MEETING NOTICE AND AGENDA
TECHNICAL ADVISORY COMMITTEE
OF THE
SEASIDE BASIN WATER MASTER

DATE: Wednesday, March 11, 2015

| <u>Agenda Item</u> | <u>Page No.</u> |
|---|-----------------|
| 3. Peer Review of HydroMetrics Laguna Seca Subarea Modeling Work | |
| A. Presentation of Draft Peer Review Technical Memorandum (Gus Yates) | 6 |

Figure 9
Hydrographs of
Sensitivity Results,
Northern Coastal Subarea

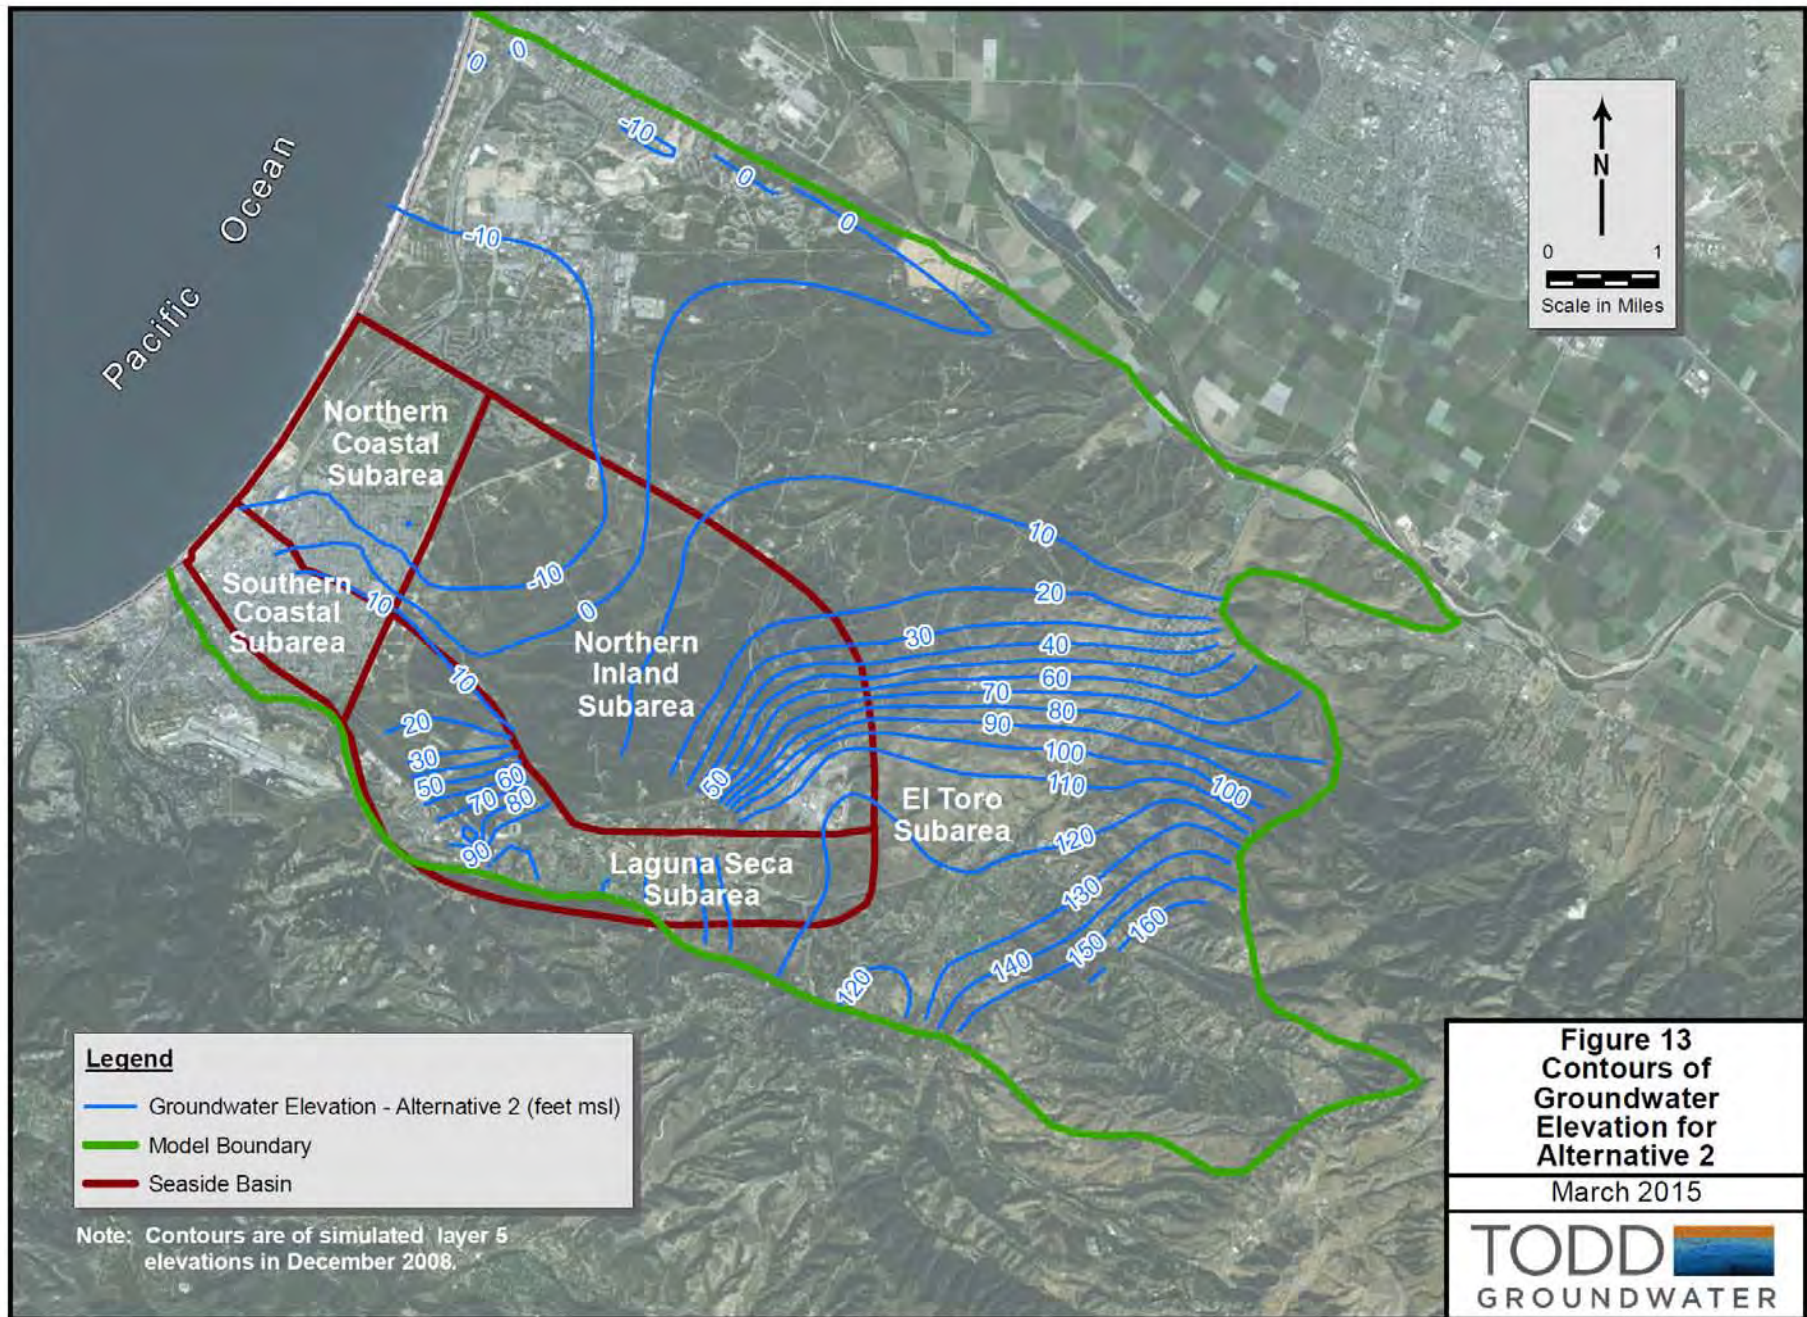
Hydrographs of selected wells are shown in **Figure 9** for the calibration simulation and the three sensitivity alternatives. The results for Alternatives 1a and 1b are slightly offset from the calibration hydrograph, but have the same slope. The long-term slope of the hydrograph is the principal indicator of basin yield. Because the slopes remained unchanged, the estimate of yield would not change. The hydrographs for Alternative 2 exhibit a different type of response. Initial water levels at the start of the simulation were much higher than the initial water levels in the calibration simulation. Over a period of about 20 years, they converged with the calibration hydrograph. This is the result of head-dependent boundary responses, which counteract perturbations that are inconsistent with inflows, outflows and aquifer parameters. Thus, the different hydrograph slope for Alternative 2 does not necessarily indicate a different estimate of subarea yield.

- Decreasing the rate of east-to-west flow across the Northern Inland Subarea did not result in simulation of a pumping trough in the Northern Coastal Subarea. Hydrographs in the Northern Coastal Subarea were shifted up or down slightly but had the same slopes as in the calibration simulation.
- In the Northern Coastal Subarea, the storage response in model layer 5 to decreased inflow from the east was the smallest of the five head-dependent boundary responses.

Figure 14
Comparison of
Northern Coastal
Water Balances

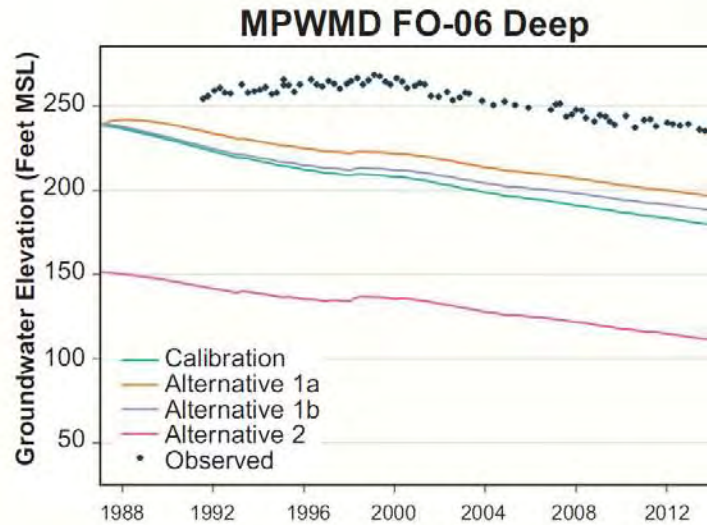
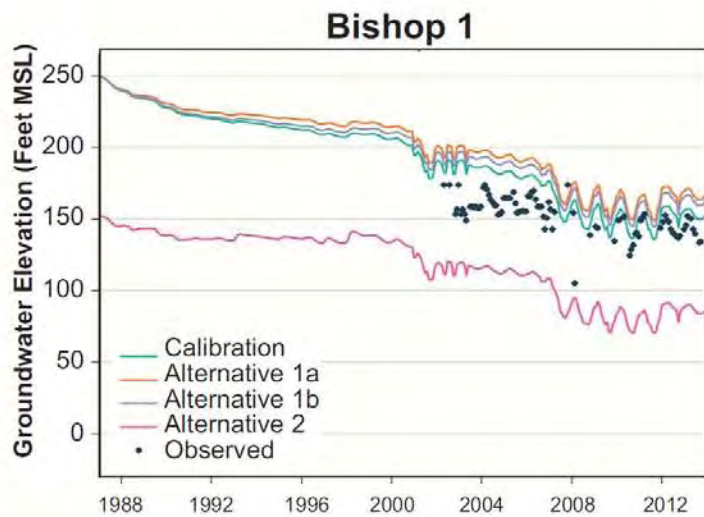
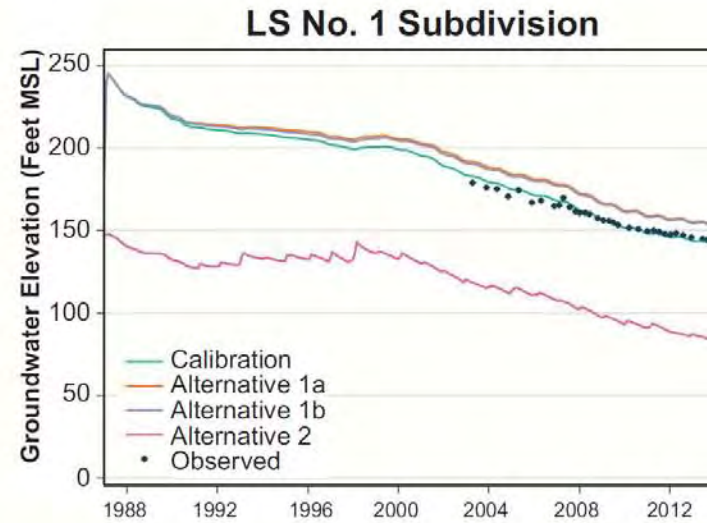
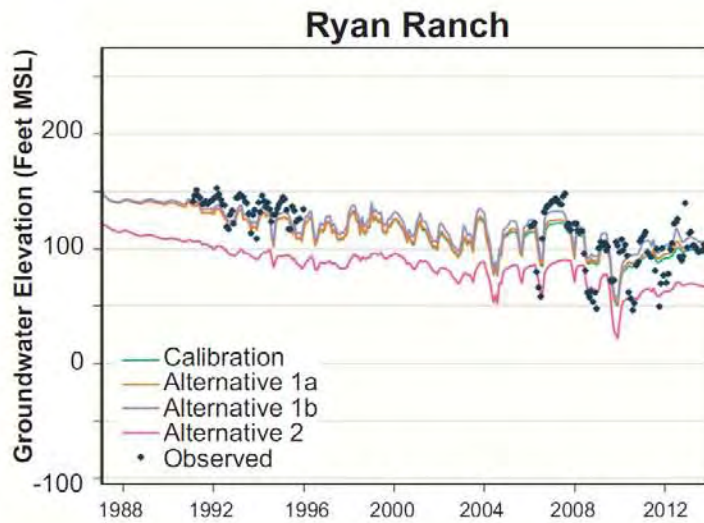
Subarea water balances were extracted from simulation results to identify how head-dependent boundaries responded to the changes in parameters and water levels. For the Northern Coastal subarea, the key question is why the calibrated model did not simulate the development of a pumping trough in layer 5 when pumping increased in 1995. Too little of the new pumping stress was absorbed by storage depletion, and too much was absorbed by other head-dependent boundary flows, which in this case include lateral net inflow from all four directions (Northern Inland, Fort Ord, Southern Coastal and the ocean) and downward flow from the Paso Robles Formation (model layers 1-4). **Figure 14** shows pie charts of average annual net inflows to model layer 5 in the Northern Coastal subarea during 1995-2013. In the sensitivity tests, the perturbation was not an increase in pumping but a decrease in inflow from the Northern Inland Subarea resulting from decreased hydraulic conductivity to the east.

The pie charts show that storage depletion was a small percentage of the Northern Coastal water balance and contributed little of the response to changes in initial water levels or inflow from the Northern Inland Subarea. In Alternative 1B, for example, Northern Inland inflow was 321 AFY less than in the calibration simulation, but the concurrent change in storage depletion was only 3 AFY.

Basically the change in one boundary inflow interacted more with the other boundary inflows than with the storage change. This implies that excessive inflow from the Northern Inland Subarea was not the primary factor hindering the model from simulating a localized pumping trough. To develop a trough, the internal pumping stress might need to be buffered from all of the head-dependent boundaries by means of locally lower hydraulic conductivity and storativity. Although this concept was not tested, it does not necessarily imply a different water balance and yield for the Northern Coastal Subarea. It could simply allow the development of a pumping trough with the same magnitude of boundary inflows.

Figure 15
Hydrographs of
Sensitivity Results,
Laguna Seca Subarea

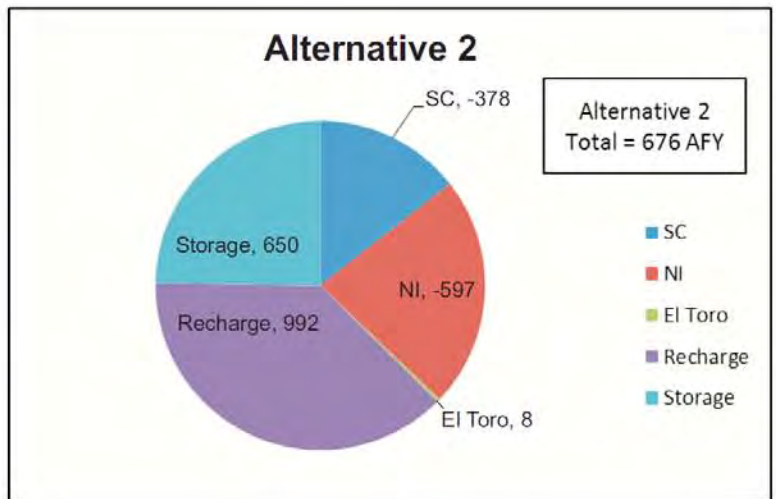
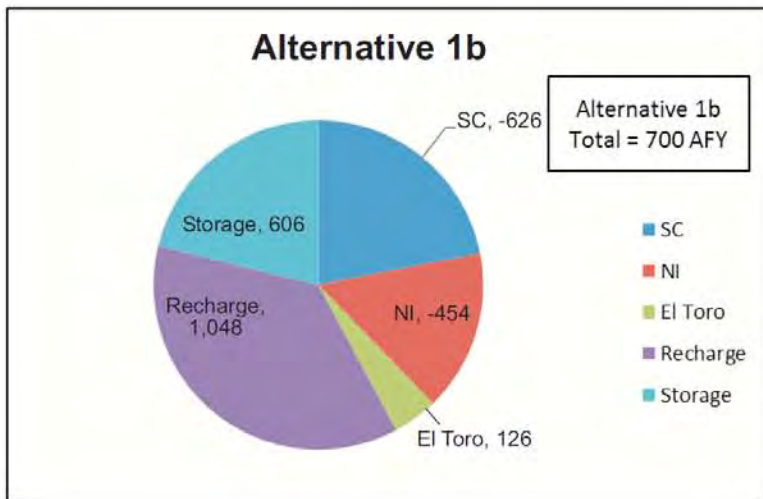
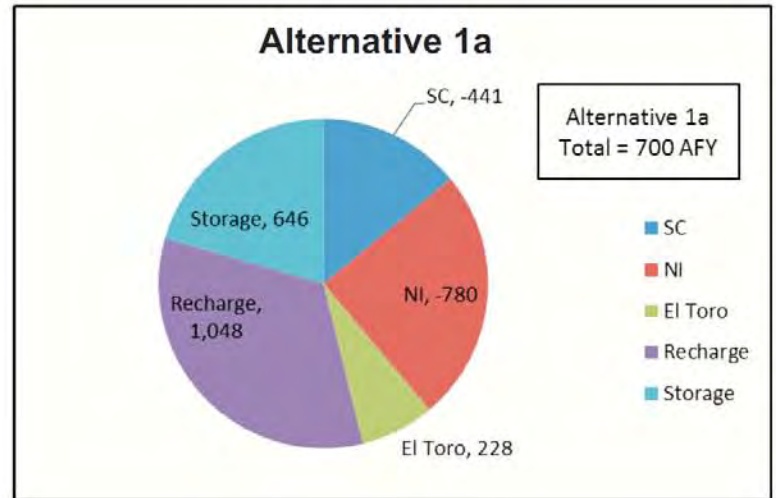
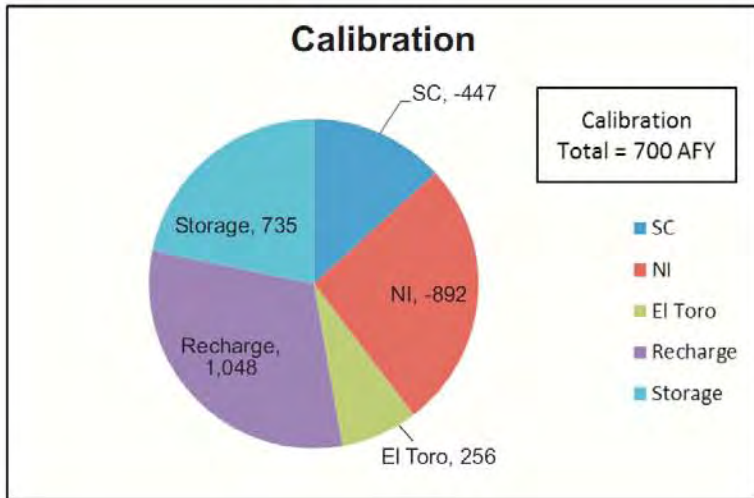
Hydrographs of sensitivity test results in the Laguna Seca Subarea are shown for four wells in **Figure 15**. The responses to the alternative simulations were similar at all Laguna Seca wells. Alternatives 1a and 1b both raised groundwater elevations in the Laguna Seca Subarea by restricting outflow into the Northern Inland Subarea, as expected. The alternative hydrographs gradually departed from the calibration hydrograph, but the effect

- The hydrographs for Alternatives 1a and 1b departed gradually from the calibration hydrographs at most wells, but only by a small amount. The alternative long-term declining trends were not sufficiently different from the calibration trends to justify a revised estimate of operational safe yield.

Figure 16
Comparison of
Laguna Seca
Water Balances

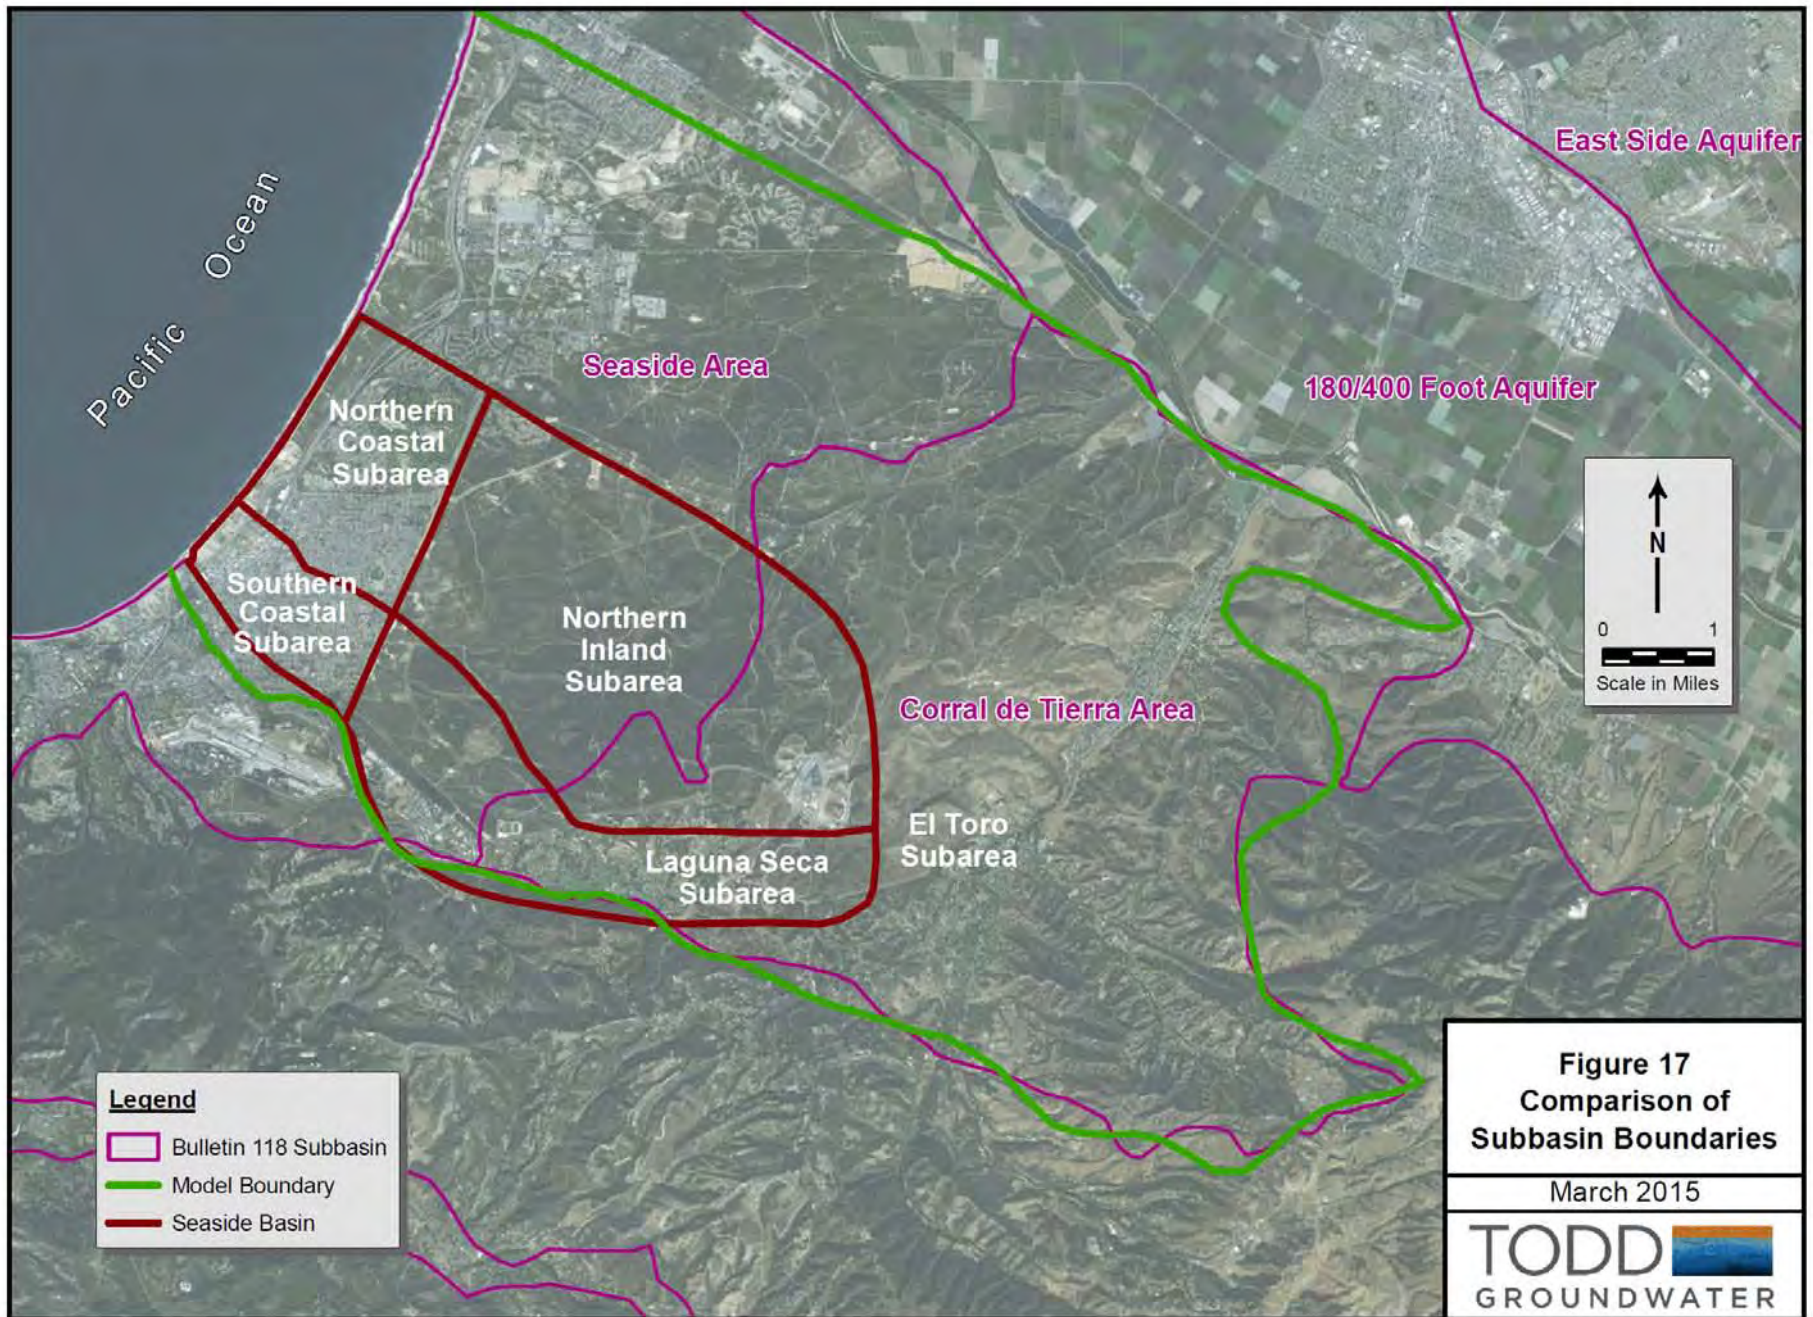
Pie charts showing average annual Laguna Seca water balances during 1995-2013 are shown in **Figure 16**. In this subarea, flow at two of the head-dependent boundaries (adjoining the Southern Coastal and Northern Inland Subareas) is predominantly outflow, so the net flows appear as negative numbers. The El Toro boundary includes an inflow segment and an outflow segment, with inflows exceeding outflows by a modest amount. The change in outflow to the Northern Inland Subarea can be viewed as the perturbation of the water balance, and the changes in storage depletion and flows across the other two head-dependent boundaries can be evaluated as responses to that perturbation. For example, the largest change in outflow to the Northern Inland Subarea was a decrease of 438 AFY under Alternative 1b. Storage depletion within Laguna Seca was smaller by 129 AFY, or 30 percent of the perturbation. Thus, storage was a larger part of the response than in the Northern Coastal Subarea, but not big enough to greatly alter the slopes of simulated water-level hydrographs.

In the simulation of Alternative 2, net inflow from the El Toro Subarea was almost zero. This can be attributed to eliminating the high water levels in the southeastern corner of the El Toro Subarea, which apparently was the source of net inflow in the calibration and other alternative simulations. However, even the substantial change in inflow and initial water levels in Alternative 2 did not cause a tremendous change in the long-term rate of storage depletion (which decreased by 85 AFY, or 29 percent of the change in outflow to the Northern Inland Subarea). Like the other tests, Alternative 2 did not reveal an obvious error in the HMWRI estimate of Laguna Seca yield.
